Torque Change - Propeller Hub Bushing 23-856163Q 1

All propeller applications using the hub bushing 23-856163Q 1

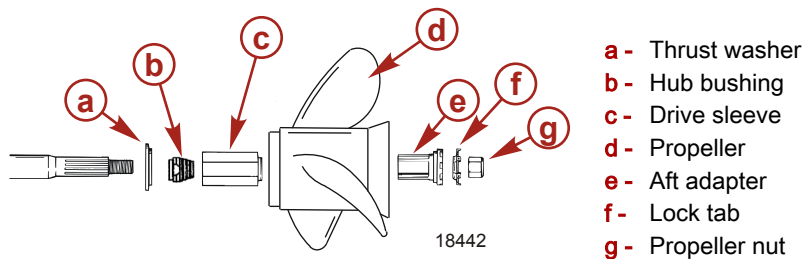
The potential exists where the present torque of 74.57 Nm (55 lb. ft.) on the propeller nut is not sufficient to allow the thrust washer to pilot into the propeller when using the hub bushing 23-856163Q 1.

An increase from 74.57 Nm (55 lb. ft.) to 135.58 Nm (100 lb. ft.) torque on the propeller nut was established to ensure the correct relationship of the propeller hub components when using the hub bushing 23-856163Q 1. The installation instructions for the Flo-Torq Drive Hub Propellers (90-832825004) will be revised to reflect this new torque requirement.
